ENCLOSURE 3
(NON-PROPRIETARY)

The attached document has been modified to reflect the use of Rosemount RTDs and is identified by the use of section, table and page numbers followed by the letter "b". A separate document reflecting the use of RdF RTDs has been written and is identified by the letter "a".

Questions:

Response: Rosemount RTDs

FIGURE 1
POWER CALORIMETRIC SCHEMATIC

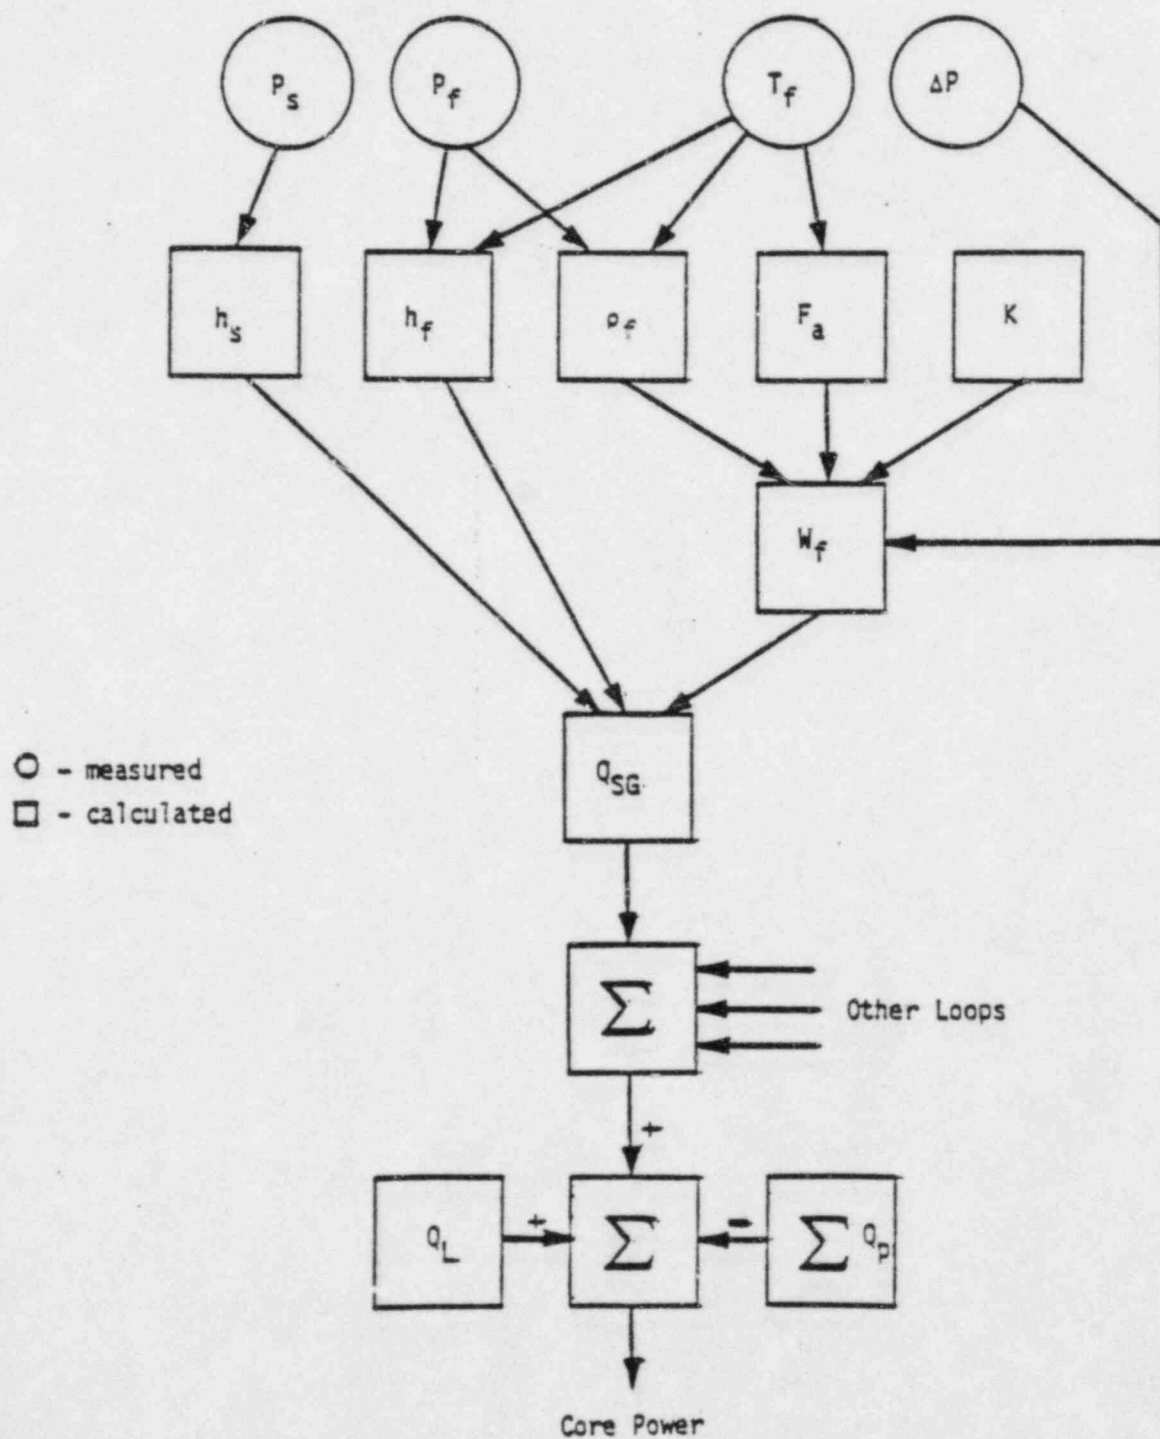
1. Provide and justify the variances and distributions for input parameters.
2. Justify that the nominal conditions used in the analyses bound all permitted modes of plant operation.
3. Provide a block diagram depicting sensor, processing equipment, computer, and readout devices for each parameter channel used in the uncertainty analysis. Within each element of the block diagram identify the accuracy, drift, range, span, operating limits, and setpoints. Identify the overall accuracy of each channel transmitter to final output and specify the minimum acceptable accuracy for use with the new procedure. Also identify the overall accuracy of the final output value and maximum accuracy requirements for each input channel for this final output device.

These measurements and calculations are presented schematically on Figure 1.
